MD 103 (MONTGOMERY ROAD)
AND OLD COLUMBIA PIKE /2ND DISTRICT FIRE STATION

GENERAL INFORMATION

DRAWING NO. TS-177F-GI OF SHEET NO. 4 OF 8

PROPOSED SIGNAL EQUIPMENT LAYOUT

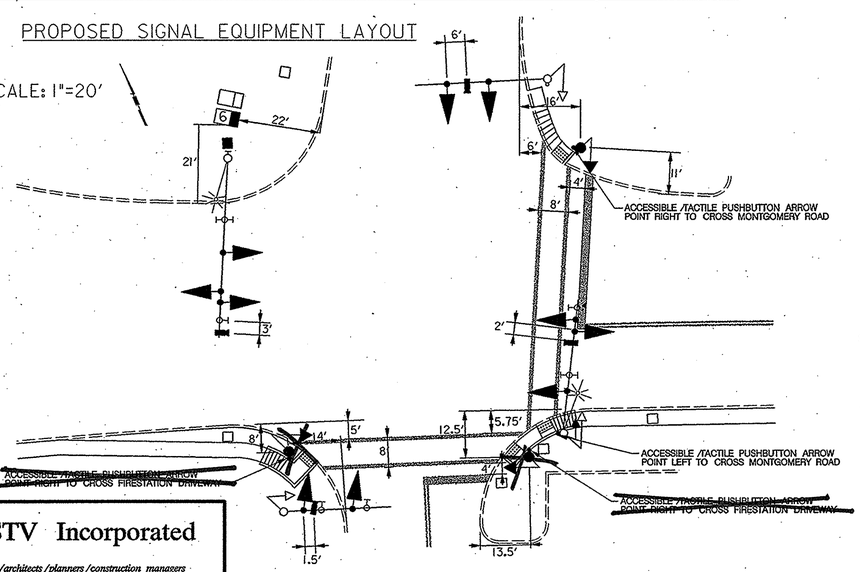
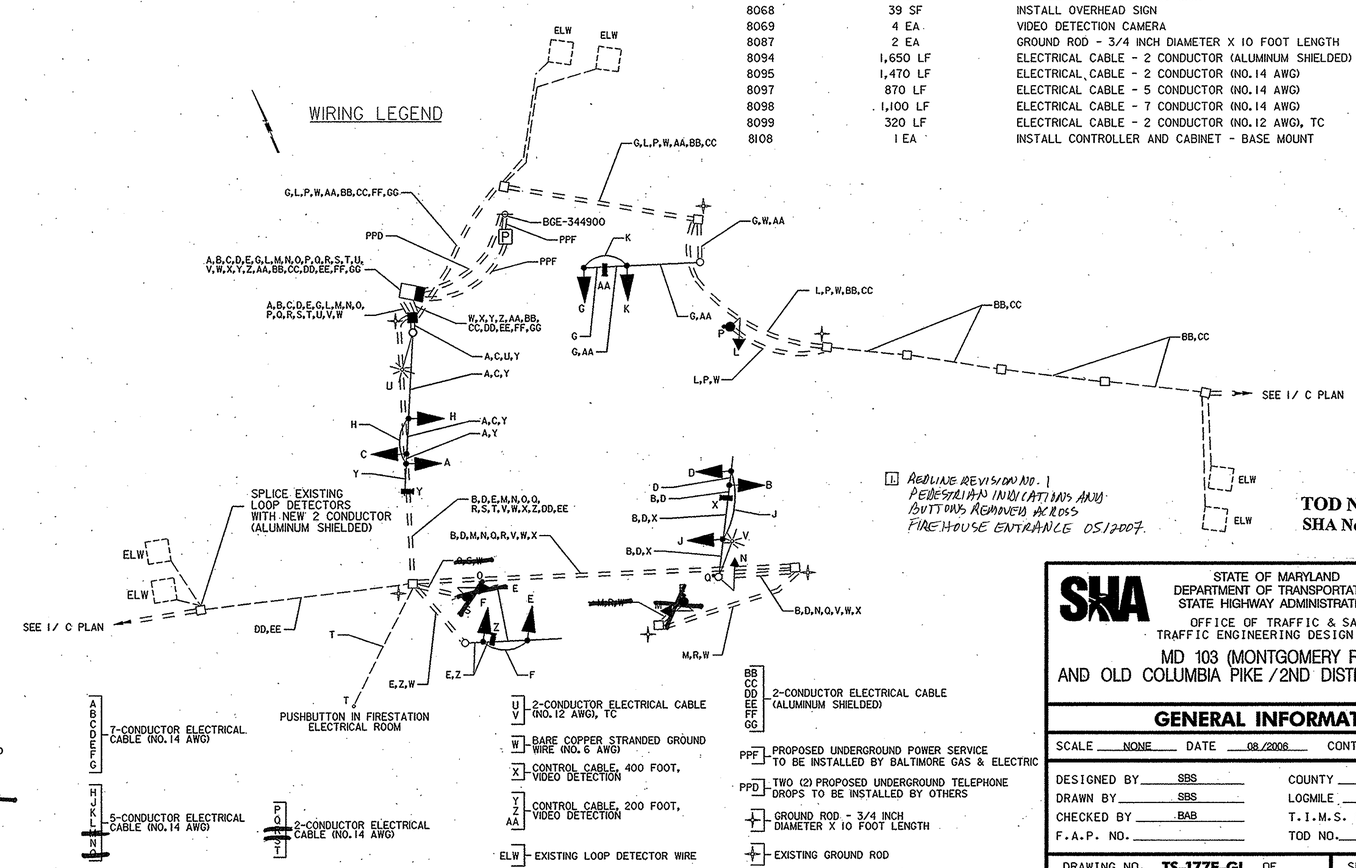
1. REDLINE REVISION NO. 1
PEDESTRIAN INDICATIONS AND BUTTONS REMOVED ACROSS FIREHOUSE ENTRANCE 05/2007.
